NO CONFORMIDADES MOLDE 25B

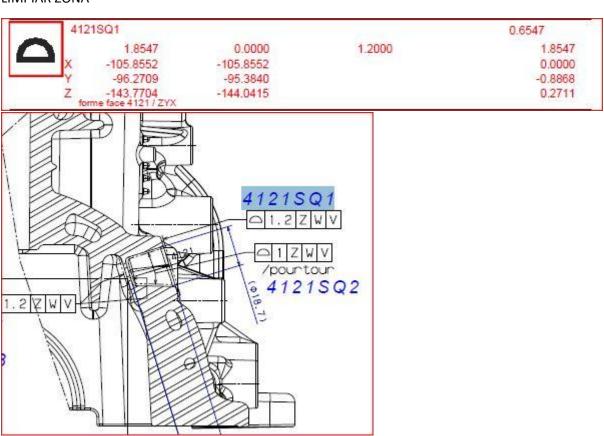
CAMBIAR PINES 3072 Y 6070

ENDEREZAR PIN 3041 (DIRECCION HACIA LA BOMBA DE AGUA)

Ф	3041L4 2.1297 Y 52.3004 Z -110.5130 loc 3041 / ZY (19.3)	0.0000 52.7001 -111.5000	2.0000	18	0.1297 2.1297 -0.3996 0.9870
O	3072L2 182.5473 loc face 3072 / X	183.3000	183.9000	182.7000	-0.1527 -0.7527
	6070L2 190.9523 loc fond 6070 / Y	192.0000	192.9000	191.1000	-0.1477 -1.0477

LIMPIAR ZONA

LIMPIAR ZONA
